Product Change Notice (PCN)

PCN Number: PCN-0451162R-01

Product(s) Affected: PJ-040CH

PREVIOUS CUI DEVICES DETAIL / IMAGE	NEW CUI DEVICES DETAIL / IMAGE

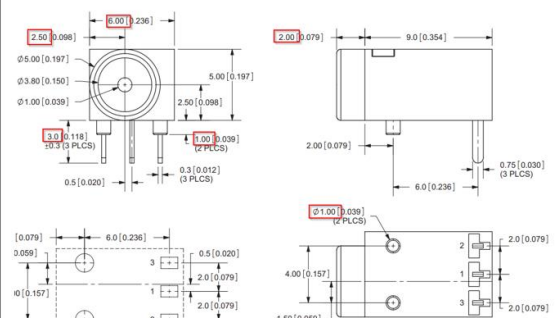
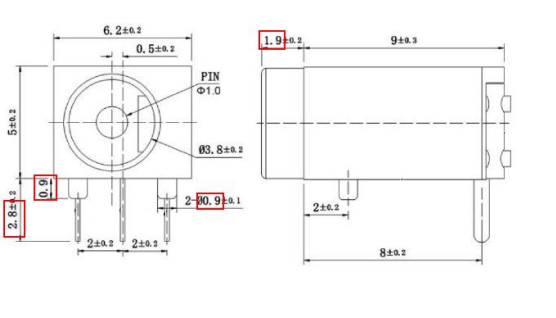
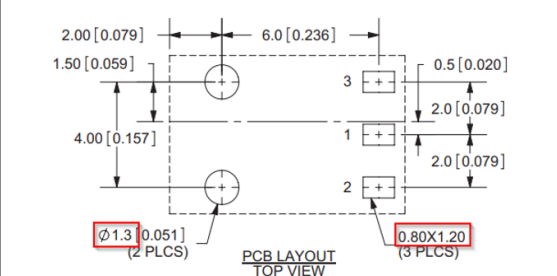
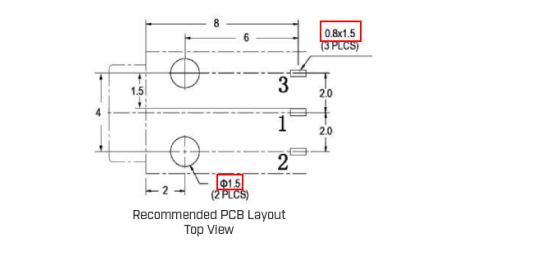
Description of Change: mechanical, material differences as shown below:

<table border="1"> <thead> <tr> <th></th> <th>MATERIAL</th> <th>PLATING</th> </tr> </thead> <tbody> <tr> <td>center pin</td> <td>brass</td> <td>silver</td> </tr> <tr> <td>terminal 1</td> <td>brass</td> <td>silver</td> </tr> <tr> <td>terminal 2</td> <td>copper alloy</td> <td>silver</td> </tr> <tr> <td>terminal 3</td> <td>brass</td> <td>silver</td> </tr> <tr> <td>plastic</td> <td>PA66</td> <td></td> </tr> </tbody> </table>		MATERIAL	PLATING	center pin	brass	silver	terminal 1	brass	silver	terminal 2	copper alloy	silver	terminal 3	brass	silver	plastic	PA66		<table border="1"> <thead> <tr> <th>DESCRIPTION</th> <th>MATERIAL</th> <th>PLATING/COLOR</th> </tr> </thead> <tbody> <tr> <td>center pin</td> <td>brass</td> <td>silver</td> </tr> <tr> <td>terminal 1</td> <td>brass t=0.25</td> <td>silver</td> </tr> <tr> <td>terminal 2</td> <td>brass t=0.25</td> <td>silver</td> </tr> <tr> <td>terminal 3</td> <td>brass t=0.25</td> <td>silver</td> </tr> <tr> <td>cover</td> <td>PBT (UL94V-0)</td> <td>black</td> </tr> <tr> <td>housing</td> <td>PBT (UL94V-0)</td> <td>black</td> </tr> </tbody> </table>	DESCRIPTION	MATERIAL	PLATING/COLOR	center pin	brass	silver	terminal 1	brass t=0.25	silver	terminal 2	brass t=0.25	silver	terminal 3	brass t=0.25	silver	cover	PBT (UL94V-0)	black	housing	PBT (UL94V-0)	black

MATERIAL	PLATING																																						
center pin	brass	silver																																						
terminal 1	brass	silver																																						
terminal 2	copper alloy	silver																																						
terminal 3	brass	silver																																						
plastic	PA66																																							
DESCRIPTION	MATERIAL	PLATING/COLOR																																						
center pin	brass	silver																																						
terminal 1	brass t=0.25	silver																																						
terminal 2	brass t=0.25	silver																																						
terminal 3	brass t=0.25	silver																																						
cover	PBT (UL94V-0)	black																																						
housing	PBT (UL94V-0)	black
